CONSTRUCTION VALUE ENGINEERING CONCEPT PROPOSAL
MISSOURI DEPARTMENT OF TRANSPORTATION

Contract ID 080425-401

VECP 08-44

Re: VE Concept Proposal
Contract ID 080425-401
Job NO. J4S1060
Route F, Jackson County

Route F VE Proposal

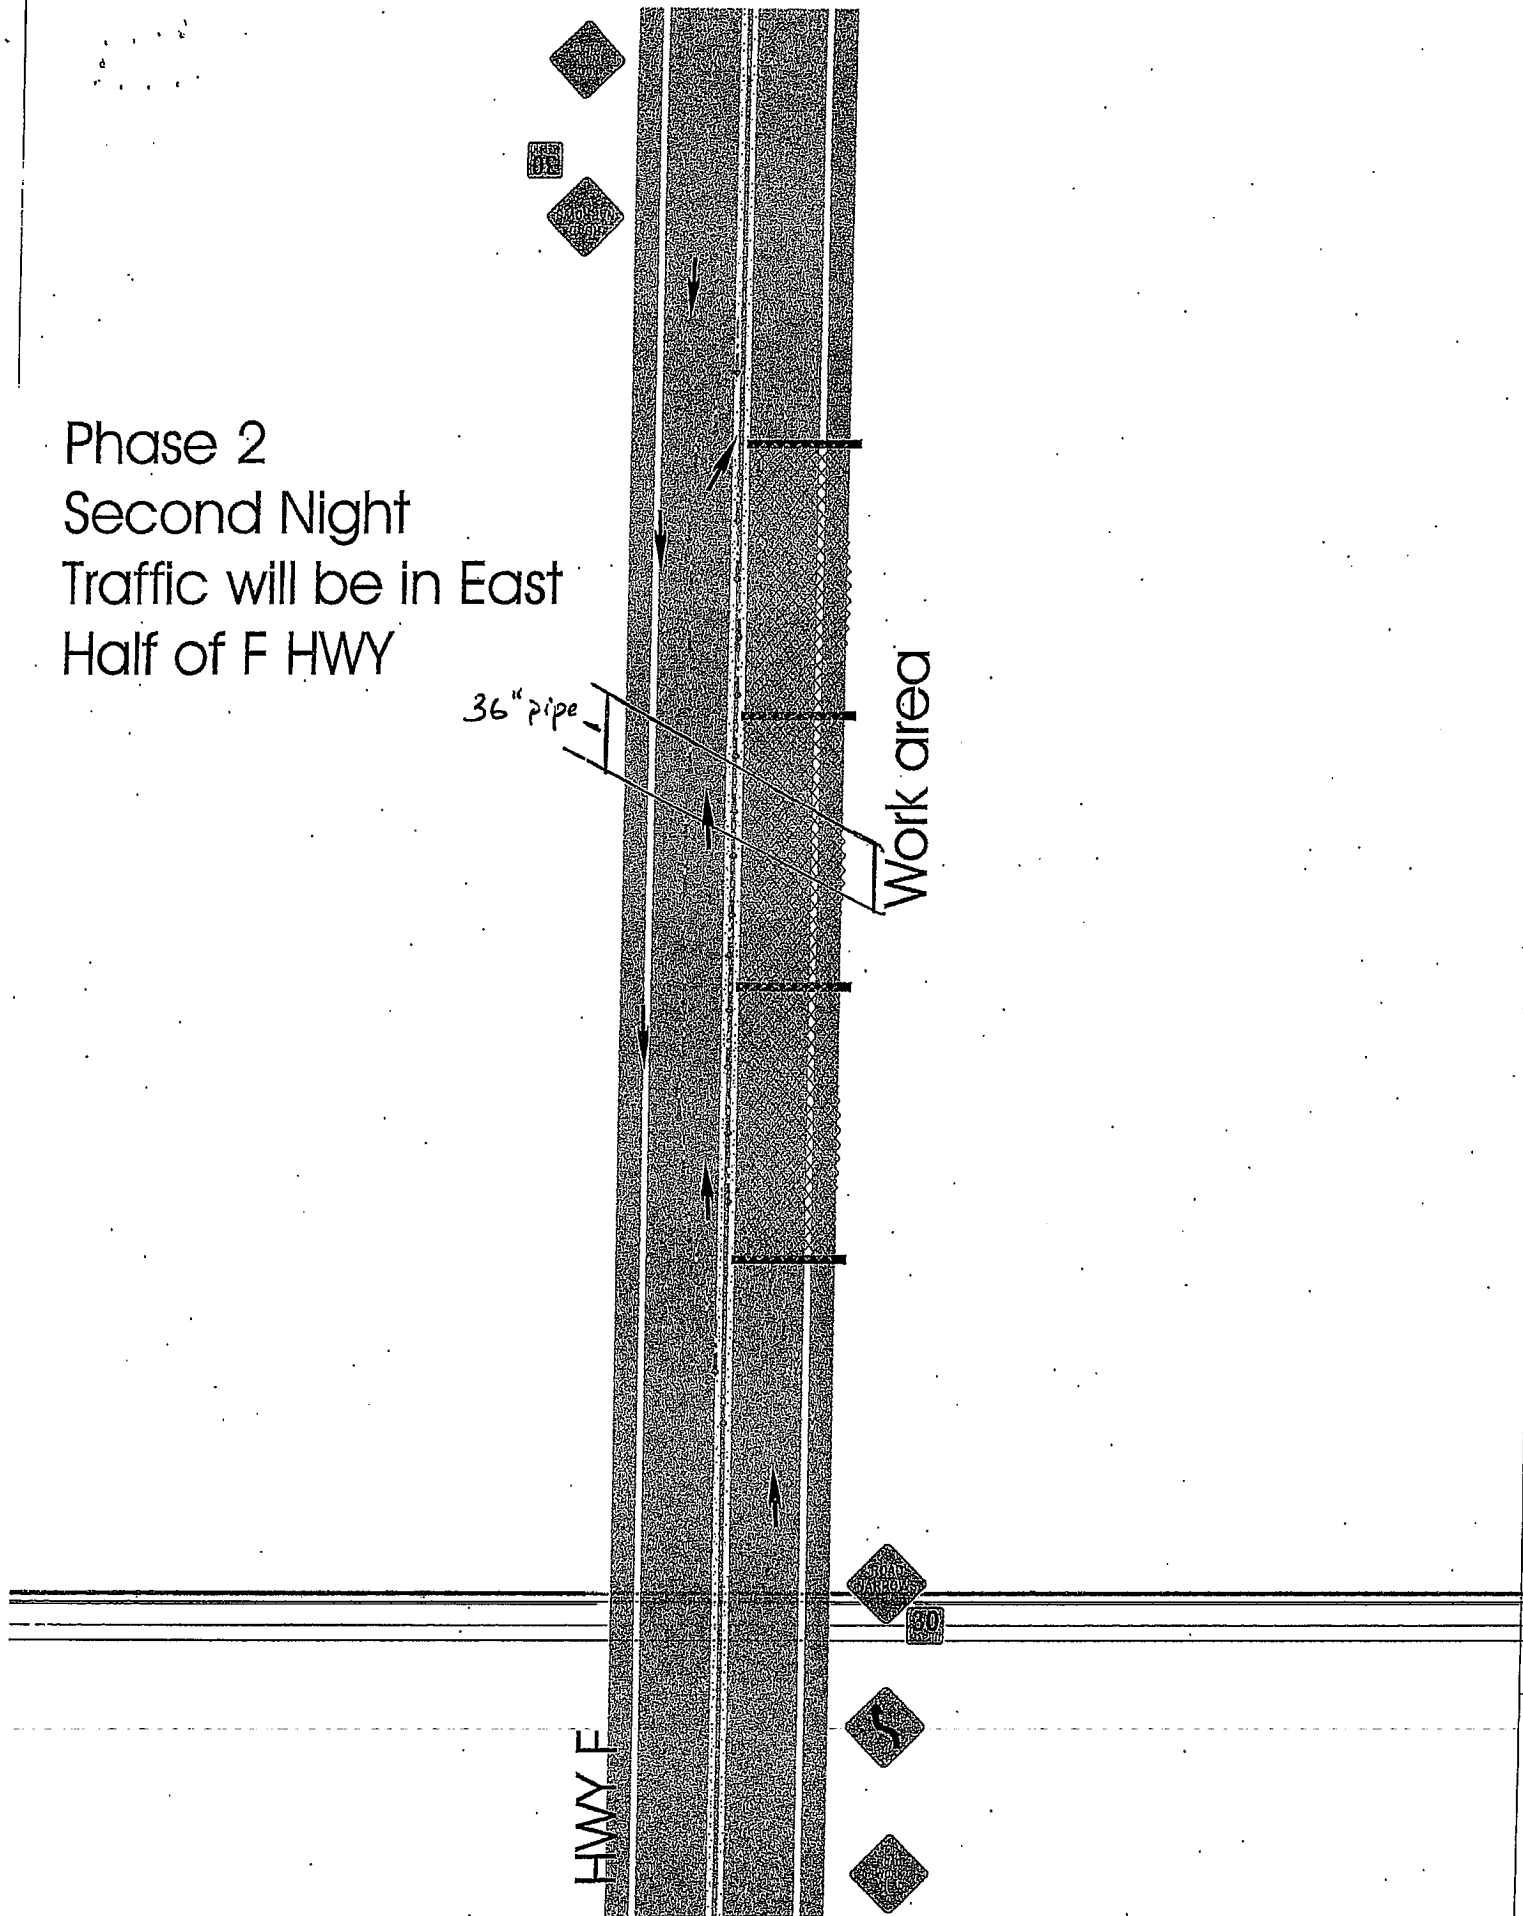
Working hours will be from 10:00 p.m. to 6:00 a.m. 2-way traffic will be maintained at all times. North access to McDonalds will be open. 4th Street access to Quicktrip will be open. The business's on the West side of Route F will not be affected. Construction will be done after their normal business hours. Truck Stop traffic will not be affected. Once backfilling is complete the area will be graded out and 8" of concrete street patch will be poured back. Street plates will be utilized in a manner to maintain 2-way traffic at all times with two 12' lanes. Estimated time of completion will be 2 working days. The total savings will be \$27,767.00.

Phase 2
Second Night
Traffic will be in East
Half of F HWY
